Project number: REL0084

### **Review of the Frequency operating standard Draft Determination**

Source: GHD, Advice for the 2022 Frequency Operating Standard review - Power system and economic impacts due to variation of the vPFCB, 21 November 2022, p.iii

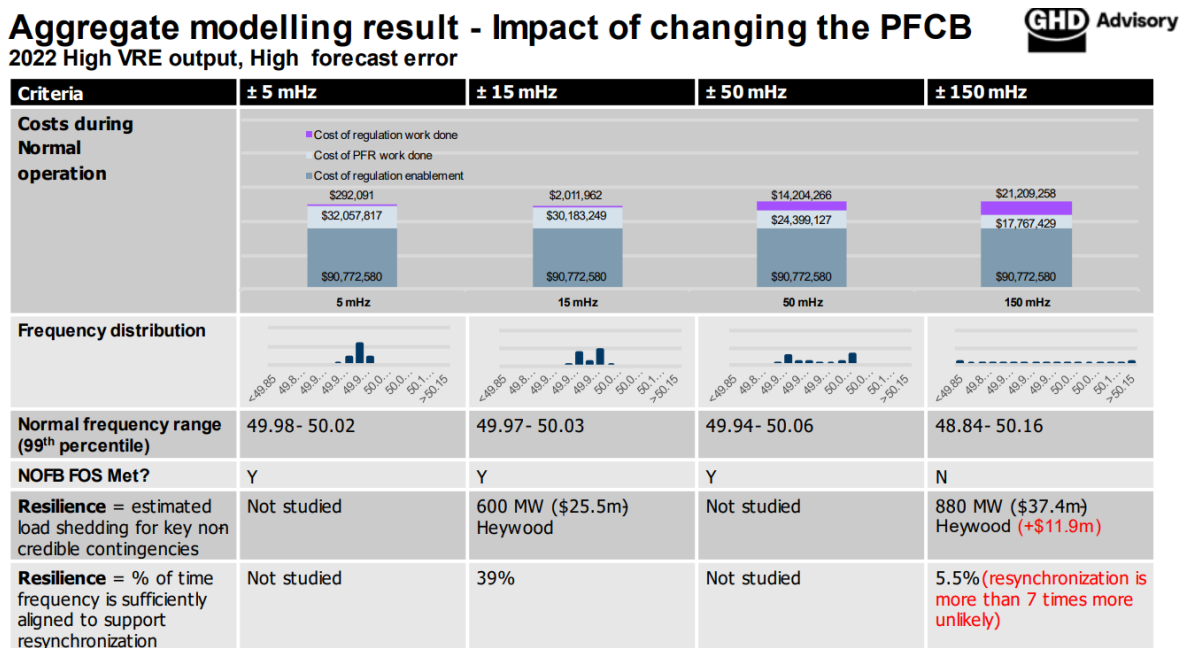
The assumptions made by GHD below in Figure 1 (shown below) has simply used historic FCAS prices which will give inaccurate forecasts. For example, it's unclear how a higher band, which would require lower PFR and higher FCAS, cost significantly higher. This is making the assumption that markets would not work to incentivise new technologies providing services and assumes that all services provided will be for free but somehow incentivise new technologies. The example is therefore assuming that the primary incentive arrangement is broken before it even starts.

The assumption is made that costs remain low when there are no incentives provided and a mandatory approach remains, taking a very short sighted and one sided approach.
